Applies To: **See VEHICLES AFFECTED****July 2003**

Product Update: 1998–99 Accord 8-Way Power Driver's Seat

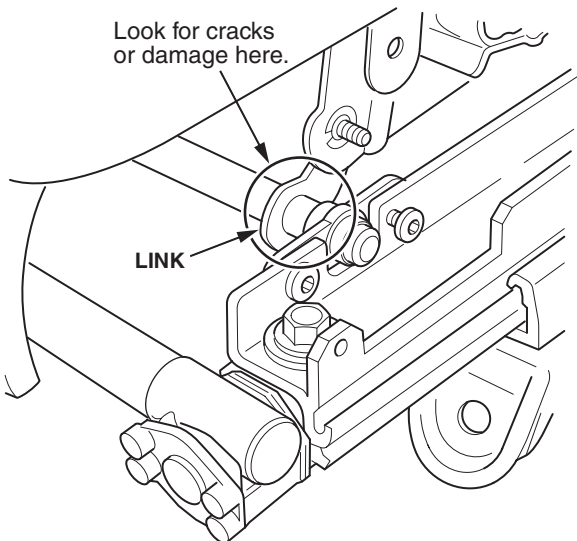
- Loosen the rear Torx screw that attaches the front torsion tube bracket to the outer seat track.
- Look for cracks or other damage on the link welded to the front torsion tube.
 - If the link is OK, go to step 9.
 - If the link is cracked or damaged, replace the seat linkage assembly (refer to the Shop Manual). After you replace the seat linkage assembly, go to step 12.

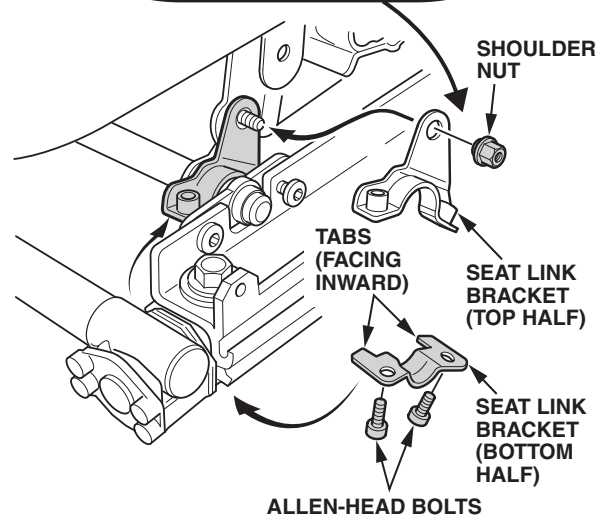
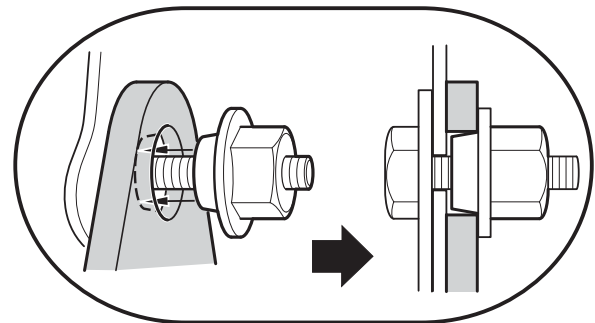
- Place the top half of the seat link bracket on the end of the front torsion tube, then attach the bracket to the recline adjuster with the shoulder nut. Center the inner flange of the shoulder nut in the bracket opening, and hand-tighten the nut.

- Position the bottom half of the seat link bracket to the top with the tabs on the bottom half of the bracket facing inward. Hand-tighten the 3/16th-inch Allen-head bolts.
- Torque the screw, nut, and bolts to these specifications:
 - Rear Torx screw: 10 N·m (2.2 lb-ft)
 - Shoulder nut: 8.5 N·m (1.9 lb-ft)
 - Allen-head bolts: 8.5 N·m (1.9 lb-ft)
- Install the recline cover and the height outer cover. Attach the two switch knobs.
- Install the seat (refer to the Shop Manual).
- Reconnect the negative cable to the battery.
- Enter the anti-theft code for the radio.
- Enter the radio station presets, and set the clock.
- Center-punch a completion mark above the 6th character of the engine compartment VIN.
